Nomination Form
Anadromous Waters Catalog

Anadromous Waters Catalog Number of Water Body 113-59-10070-2070

113-59-10070 Tributary 4

ADDITION

Map #2

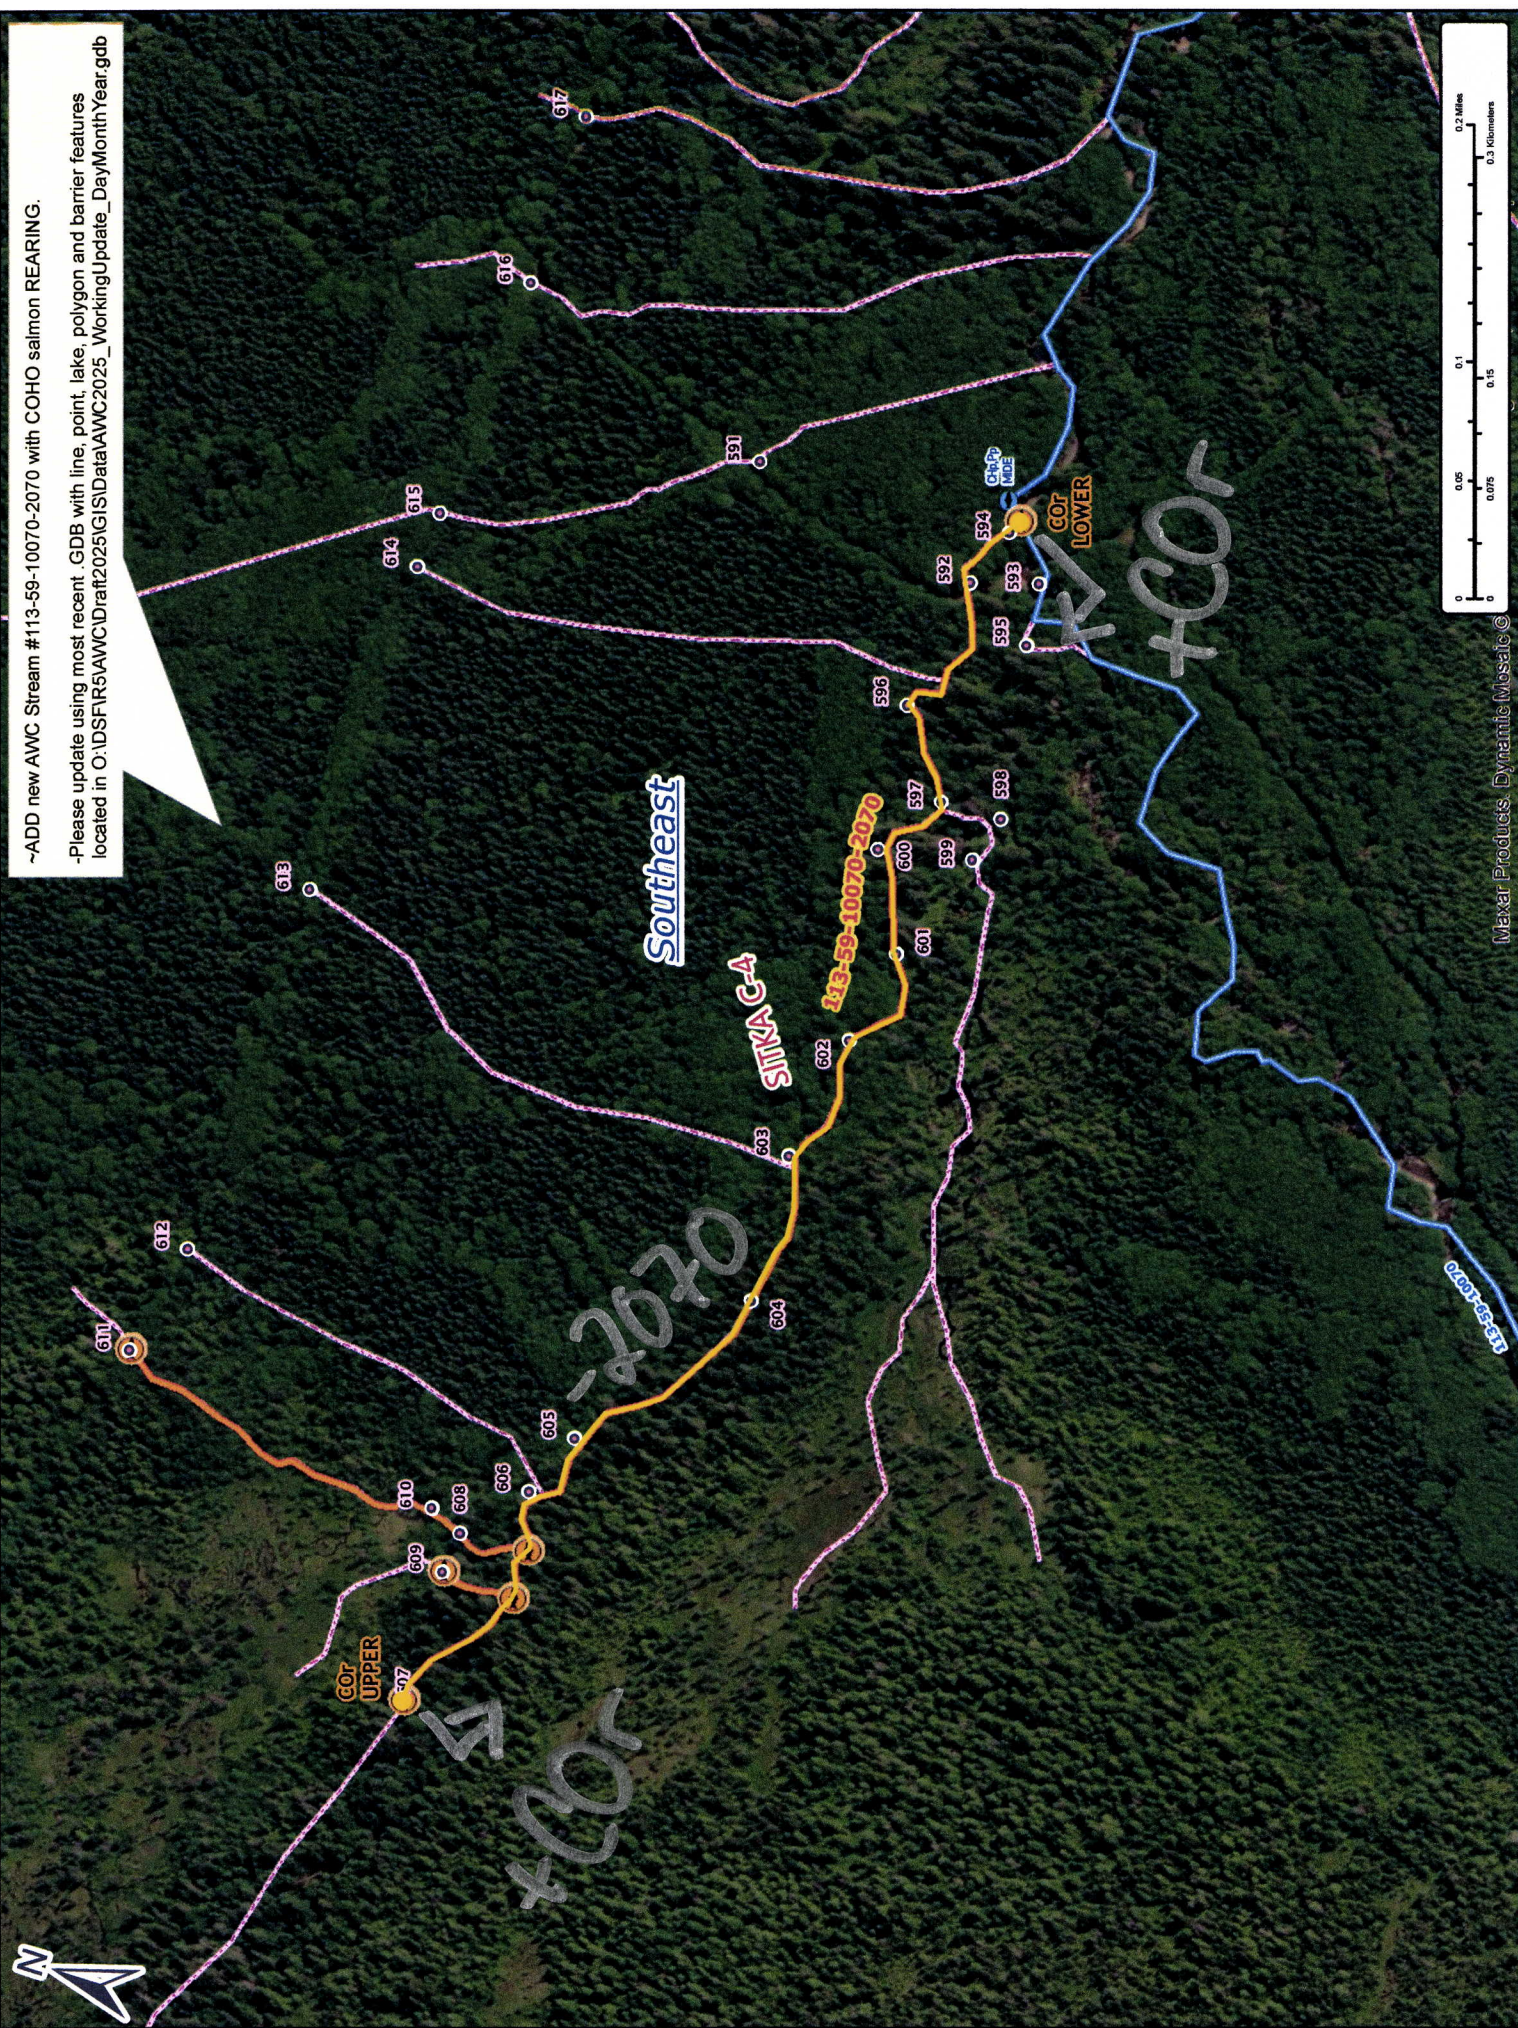
~ADD new AWC Stream #113-59-10070-2070 with COHO salmon REARING.
-Please update using most recent .GDB with line, point, lake, polygon and barrier features located in O:\DS\FIR5\AWC\Draft\2025\GISData\AWC2025_Working\Update_DayMonthYear.gdb
